Office Action Summary	Application No.	Applicant(s)	
	10/774,603	FOSSUM, ERIC R.	
	Examiner	Art Unit	
	Nelson D. Hernández Hernández	2622

DETAILED ACTION

9. **Claims 26-28, 30-35, 37, 38, 40, 42 and 58 are rejected under 35 U.S.C. 102(a) as being anticipated by Denyer et al., WO 97/35438 A1.**

FIG. 6

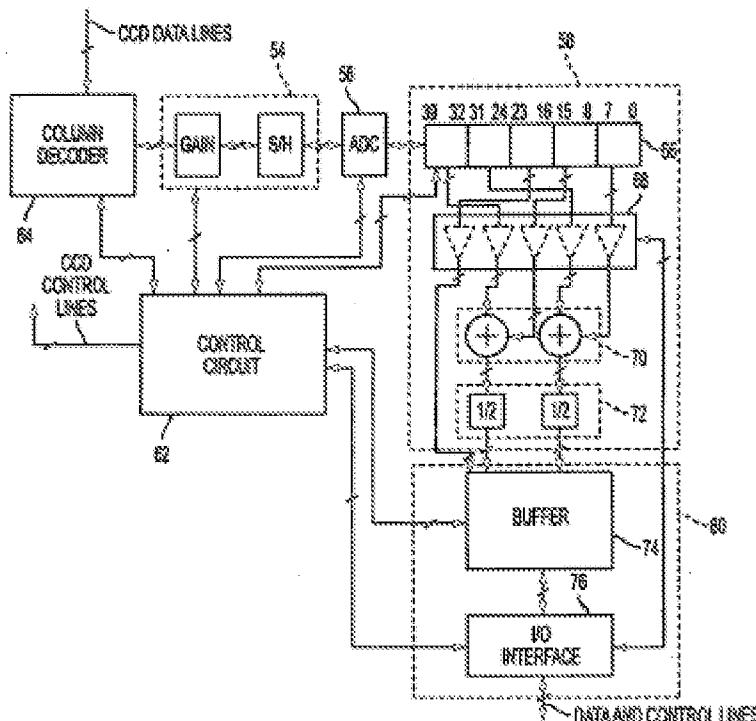
6. **Regarding claim 60**, claim 60 recites "...the interpolator further comprises five scalar multipliers for multiplying the digital bit values of the spectral component measurements from the photosensitive site being interpolated and the four photosensitive sites neighboring the photosensitive site being interpolated". The Examiner noted that the Specifications (See page 15, line 14 – page 16, line 8) recite :

It is noted that the Specification offers support for “multiplying the digital bit values of the four photosensitive sites neighboring the photosensitive site being interpolated” (*digital bit values of the four photosensitive sites neighboring the photosensitive site being interpolated being represented by bit values 0-15 and 24-39 as shown in fig. 6*) (*In Page 15, lines 19-21 specifically*), but does not appear to have support for “multiplying the digital bit values of the spectral component measurements from the photosensitive site being interpolated” since it is noted that the spectral component value of the photosensitive site being interpolated (*corresponding to bits 16-23*) is transferred to the buffer 74 without any further processing, that is the value of the photosensitive site being interpolated is not multiplied by a weighting coefficient but directly transmitted to the buffer. The Examiner understands that the fact the fig. 6

appear to show an amplifier (or scalar multiplier) receiving the bit values 16-23 does not necessarily suggest that the value for the pixel being interpolated is multiplied to have a particular weight value. Therefore, the Examiner understands that claim 60 contains subject matter which was not described in the specification in such a way as to reasonably convey to one skilled in the relevant art that the inventor, at the time the application was filed, had possession of the claimed invention.
